| Number | 0.1 |
| Section | Heating and Windscreen Washing Equipment |

WINDSCREEN WASHING EQUIPMENT - FROST PRECAUTIONS

INADEQUATE HEATING

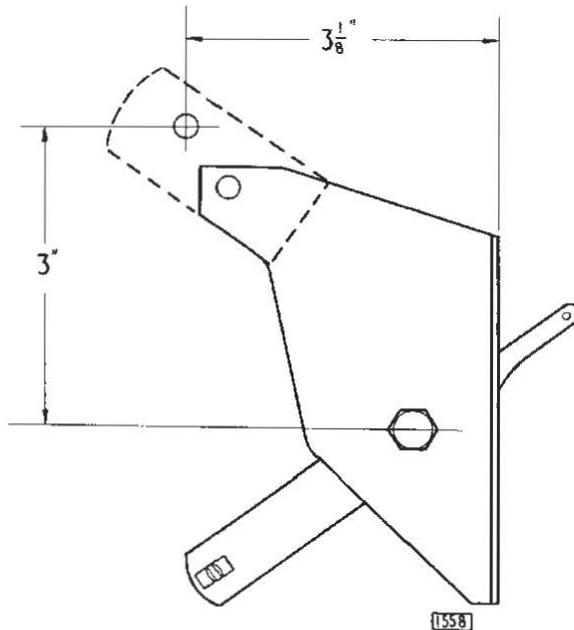
If complaints are received of insufficient heating and demisters blowing cold when the control is in the HOT position, carry out the following rectification procedure:-

- (1) Place the control in the "Hot" position.
- (2) Check the uppermost of the two levers on the engine side of the heater box for further travel. (Note: a small amount of extra travel due to compression of the foam rubber sealing strip is normal).
- (3) If extra travel exists this indicates that the heater flap is not closing fully and it will be necessary to carry out the following modification.
- (4) Remove the casing from the left-hand side of the heater panel by unscrewing the two knurled nuts. Detach the Hot-Cold knob by unscrewing the screw in the side of the knob. Remove the two nuts at the rear of the operating lever bracket and detach the bracket. Disconnect the cable and remove the outer cable clip.

- (5) Make up an extension strip from 16 S.W.G. (.064" - 1.6 mm) steel and weld or bolt it to the control lever bracket in the position shown.
- (6) Refit the outer cable clip to the hole in the extension strip.
- (7) Reconnect the cable and refit the bracket.
- (8) Re-check operation as described in paragraphs 1 and 2.

(16 SWG 0.64" 1.6MM)

FIG 1

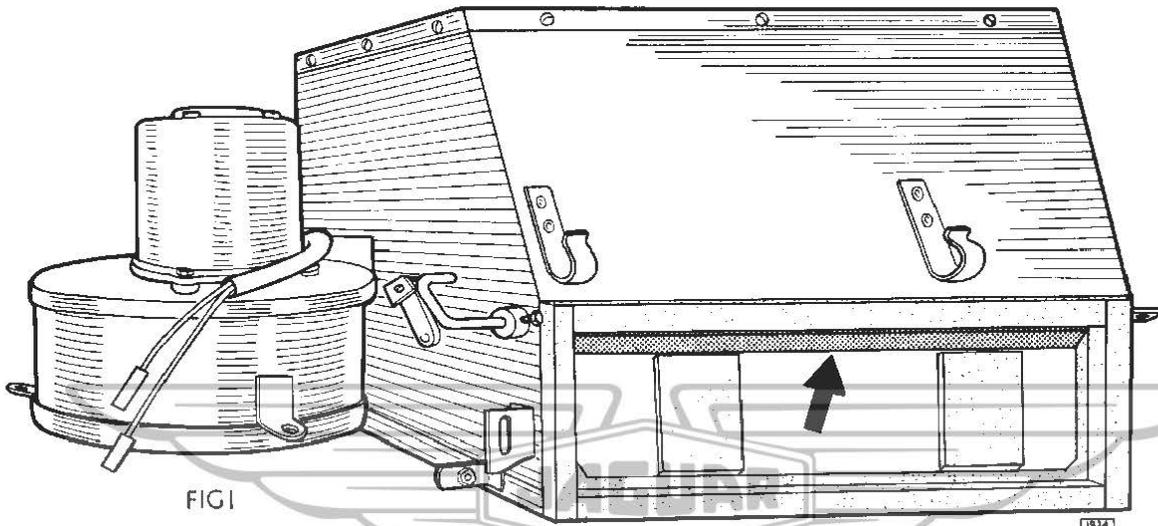
If on early Mark 2 cars not equipped with a water valve (see Service Bulletin number 0.2) trouble is experienced with the heater delivering warm air when the control is in the "cold" position the following procedure should be carried out:-

If the flap is found to be closing fully it will be necessary to remove the heater and fit sealing strips in the following manner.

2. Affix a piece of polyurathene (Part number C.15966) to seal the gap at the hinge of the lower flap as shown in Fig.1.
3. Remove the end cover plate (11 screws) and affix a piece of polyurathene (Part number C.17408) to seal the gap adjacent to the upper flange hinge (see Fig.2.)
4. When replacing the heater matrix in the box ensure that the long strip of black felt affixed to one side of the matrix is uppermost.
